Document Number: NA	Document Title: Briefings to LFRG on EMDF Performance Assessment and Composite Analysis		
Organization/Project: UCOR/EMDF	Comment Due Date:

Reviewer	TDEC
-----------------	------

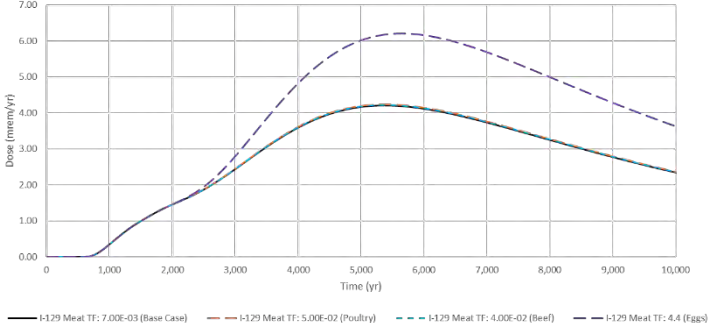
Comment No.	Presentation Slide	Comment/Suggested Change/Rationale	Response
			<p>will increase the water level beneath slightly, will actually cause more groundwater mixing from the waste to the boundary due to additional uncontaminated water recharge along the flow path. Also see the note in the response to Comment #8 above.</p> <p>The clay liner layer will stop at edge of the cover system. The berm starts at the edge of the cover system in the model.</p> <p>In response to this comment, the infiltration rate for the berm was re-evaluated. Using an average K value for site-specific slug tests, and the K values and the recharge rates used in the shallow zone in the site-specific groundwater model, it was decided that the infiltration rate for the berm has will remained 1 in./yr in the revised PA.</p>
12	<u>Slide 42</u>	Regarding a 0 my/year erosion rate of clean cover, Section 7.2.1 of the PA provides some explanation for why erosion modeling was not considered. Much of the explanation seems assumed; similar to other LFRG reviewer comments, a more detailed defense of this rational should be provided.	<p>Discussed September 20.</p> <p>Cover surface erosion modeling was performed used RUSLE2 and presented in Appendix C (Sect. C.4).</p>
